Case #: PB 2014-03
Date: February 13, 2014
Recommendation: Denial

PLANNING STAFF REPORT

Site: 337-341 Broadway

Legal Notice: Applicant, Winter Hill Bank, FSB, and Owner, KLT Corp., seek a Special Permit under SZO §6.1.22, for new signage. CCD 45 zone. Ward 4.

337-341 Broadway – previous signs for Citibank – (top left) along Broadway, (top right) facing parking lot, (bottom left) pylon sign, (bottom right) elevation show for original special permit approval

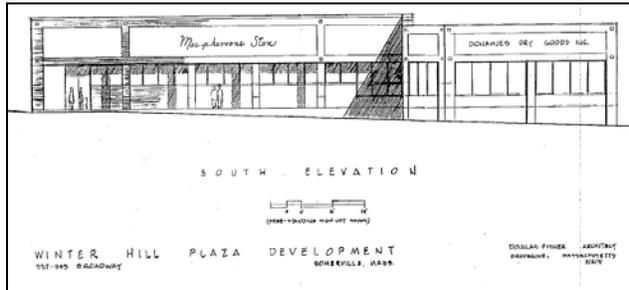
The third sign on the building is a new sign that does not comply with the design guideline for signage in the CCD (§6.1.22.H). Large interior-lit box signs are discouraged and Planning Staff do not recommend approval of this sign with its proposed design. These signs are discouraged because they overwhelm the façade of the building. They are also oriented towards fast moving vehicles and in this district signs should be oriented towards pedestrians creating a positive experience along the street. Existing or future businesses moving into the shopping center or neighboring properties will likely want to install larger signs with the same level of or brighter lighting to compete with the signage that is proposed for this tenant.

Planning Staff find that if the third sign is made of a material that is not discouraged (vinyl or plastic) and is either not lit or externally lit, it will not be as dominant and would be acceptable. Ideally the other two signs on the building would also comply with this standard.
